PIC18F26/46/56Q43 Silicon Errata and Data Sheet Clarifications

PIC18F26/46/56Q43

1.7.1 UART TXDE Signal May Go Low before the STOP Bit Has Been Entirely Transmitted

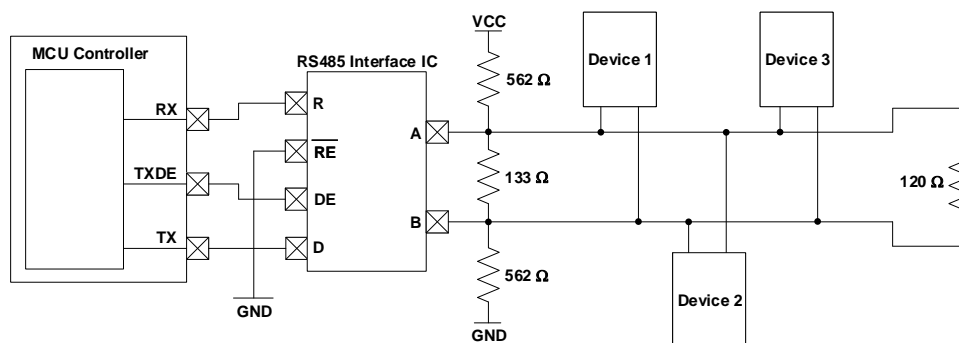
The UART Transmit Drive Enable (TXDE) signal could potentially transition into a low state before the UART STOP bit has been entirely transmitted due to the effects of parasitic capacitance on the TX line. In some applications, this could result in communication being prematurely terminated due to the TXDE bit going low before the STOP bit has had enough time to settle.

To ensure that the STOP bit settles into its final logic state before the TXDE signal transitions low, a biasing circuit can be implemented. A biasing circuit allows the TX line to either be driven high or low, rather than being left in a floating tri-state mode where prolonged rise or fall times could lead to communication being disrupted. This bias circuit should only be implemented on one end of the serial bus, and a termination resistor should be used on the other end. The figure below shows an example of a bias circuit that can be used to achieve this.

Please note that the resistor values used in this circuit are recommendations and that the actual resistor values required may vary based on the application.
